Submission to

# Casey Fields South Employment & Devon Meadows PSP & Amendment C295case

95 Devon Road, Devon Meadows

**Issued**  
31 March 2025

Figure 1: Extract from PSP Plan 2: Place Based Plan (VPA 2024)

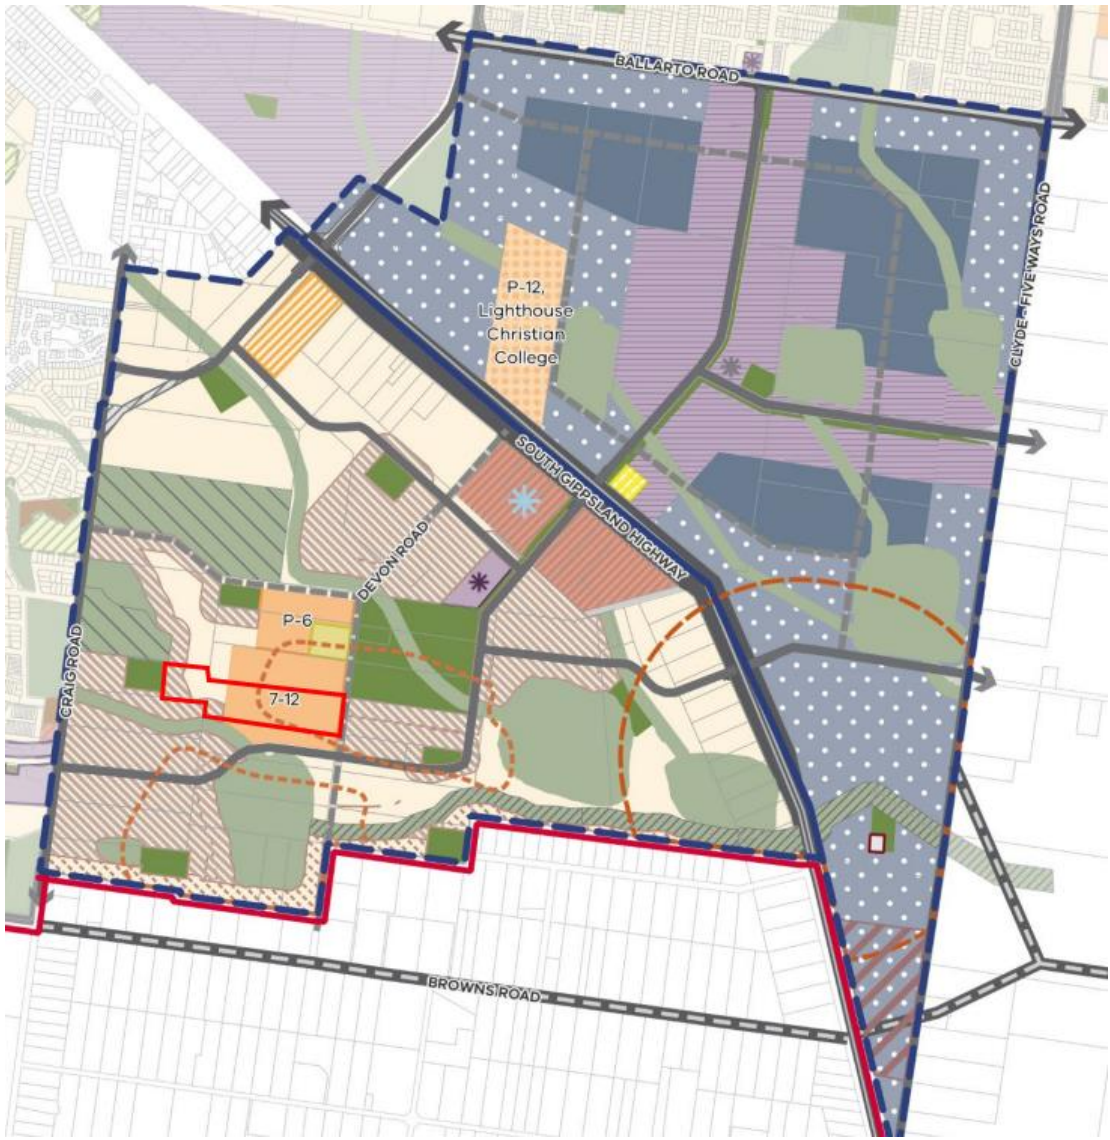
The draft CFS&DM PSP identifies a government secondary school across approximately tow-thirds of the site (3.44Ha). A mix of *Increased Amenity* (high residential density) and *Balance Area* (standard residential density) is proposed over the remaining third of the site which is located at the rear of the property.

95 Devon Road is centrally located within the Devon Meadows precinct and is identified as property ID# DM67. The draft PSP indicates that the subject site will support a government secondary school on approximately two-thirds of the site with the remaining land nominated for increased and standard residential development. The school is earmarked as a medium to long-term project, partially due its encroachment into the South Gippsland Eggs separation buffer.

The majority of the subject land is earmarked to support a government secondary school. It is submitted that the school should be relocated to the Clyde South residential precinct to better serve a larger catchment area with a single facility. The Community Infrastructure and Open Space Needs Assessment (CIOSNA) indicates low demand for a secondary school within CFS&DM, with the need primarily arising from the VPA target requiring all residential areas to be within 3.2km of a secondary school. This approach is seen as unresponsive to the local context and should be reassessed in light of the neighboring future residential PSP.

Figure 5: Existing school catchment (orange), VPA proposed (blue) and BW proposed catchment area to capture Clyde South residential PSP (green).

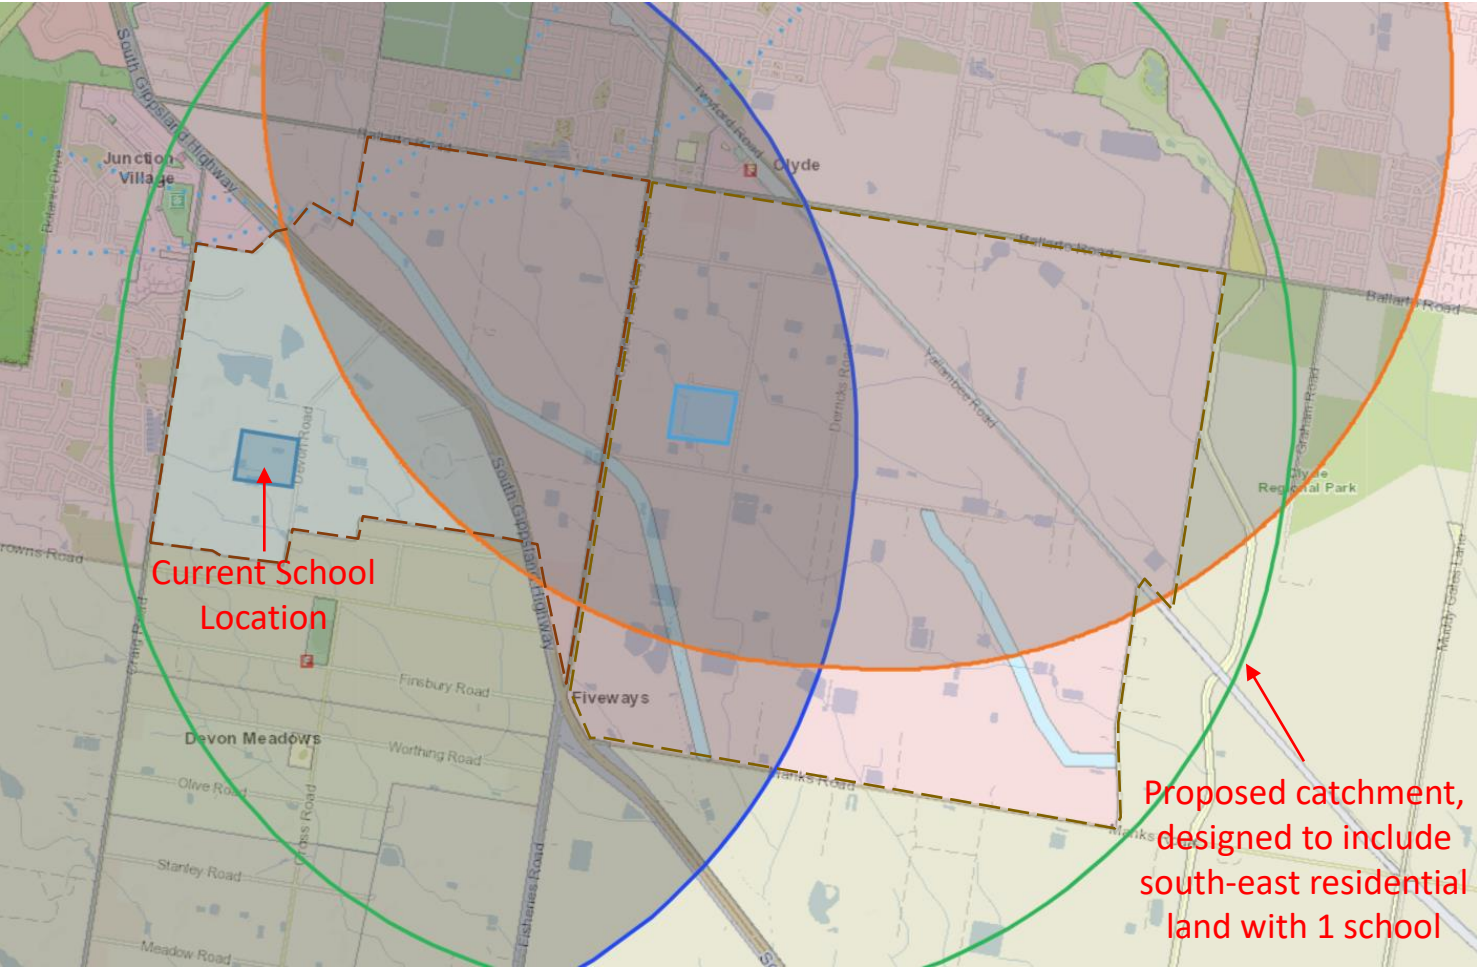
Figure 5 identifies the current school location within the CFS&DM PSP and shows the 3.2km catchment area in blue. The current proposed placement of the school results in the south-eastern portion of the Casey Fields South PSP being outside of the 3.2km coverage area. The image also highlights the existing Clyde Secondary College catchment (in orange), which extends well into the Clyde South PSP and partially into the CFS&DM PSP areas. The broad reach of this catchment may explain the low demand observed within the CFS&DM PSP, and it also suggests that there may be a similar low demand for a secondary school within the Clyde South precinct.

It is evident that the current placement of the proposed secondary school on our client's land will likely trigger the need for an additional secondary school within the Clyde South PSP to service the future residents of that precinct that fall outside of the existing Clyde Secondary school catchment area. It is therefore submitted the proposed secondary school be relocated to the future Clyde South precinct where a single school could service the Devon Meadows and Clyde South catchment areas in totality.

It is submitted that re-locating the proposed secondary school will provide a net community benefit by reducing asset requirements and land allocation, making more efficient use of infrastructure and reallocating land to facilitate housing development to its maximum extent and in a timely manner.

Further, shifting the school location as proposed better meets PSP Guidelines Feature 14.3, which states *the provision of new infrastructure should [...] reflect the most cost-efficient approach to addressing service needs. This includes making use of any spare capacity of existing facilities within the catchment area.* It is submitted that allocating land for two assets when one can be delivered in a more optimal location does not support this outcome.
